HD Engineering & Design

FRAMING ADDENDUM

RE: PRRES20212466
508 SE DAVID RD
LEE'S SUMMIT, MO.

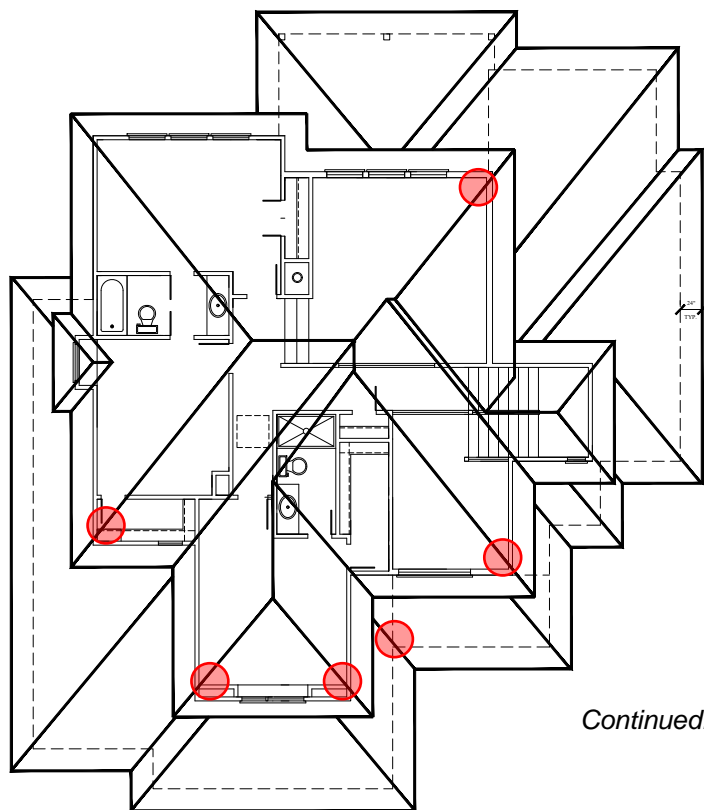
- Overnotched hip joist at entry/ garage beam
- Address ceiling joist, hip, rafter and beam taper cuts and overnotched rafters throughout

There are several locations where the hip and valley seat cuts have been over cut to allow clearance. After review of the roof loads our firm has identified the locations (see below marked in red) in need of additional reinforcing to ensure proper transfer of roof loads. The locations marked will be reinforced with a layer of 7/16 OSB attached as shown in the detail below.
